## Accessibility Survey

### City of Downey

### Priscilla Street - Carfax Avenue to Faust Avenue

**Disability Access Consultants**

**Change In Level East Of Brock Avenue @ 33.916956867832, -118.154160976410**

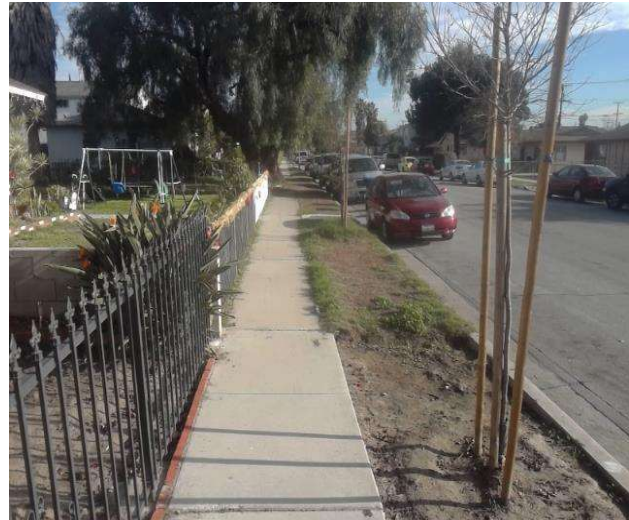
There is a change in elevation greater than recommended value.

**On-Site Finding** 0.75 inches

Ensure that the change in elevation is within the recommended value.

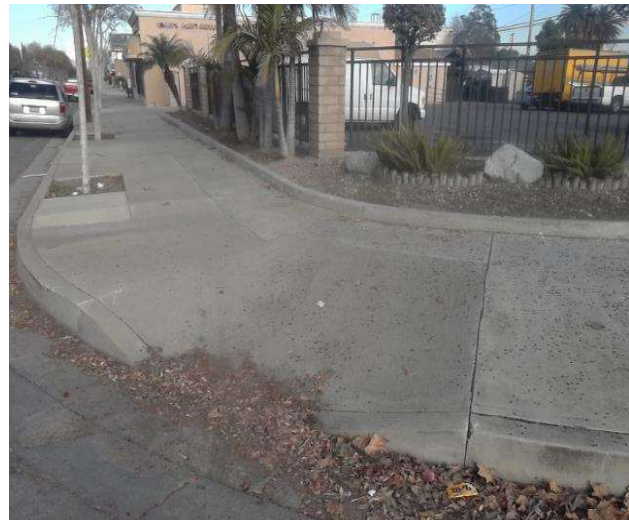
The bottom landing of the curb ramp is on the street, and the slope of the bottom landing is not compliant.

**On-Site Finding** 10.50 percent

Ensure the bottom landing slope is compliant and provides a smooth transition.

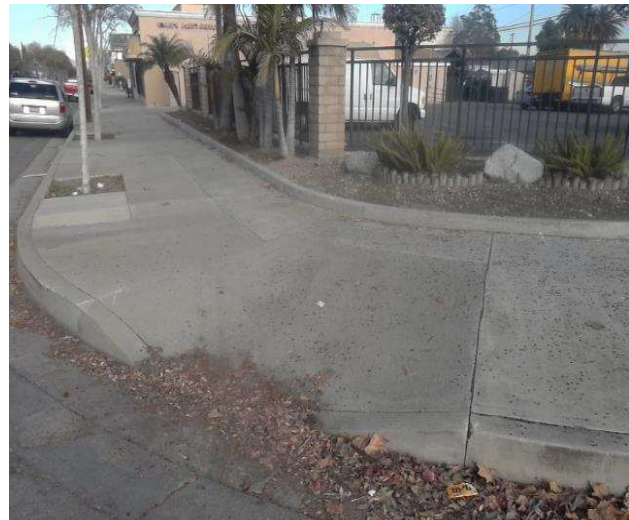
The slope at the top landing is greater than allowed.

**On-Site Finding** 2.20 percent

Provide a top landing surface that does not exceed the maximum slope and cross slope. Provide a sufficient maneuvering clearance that does not accumulate water.
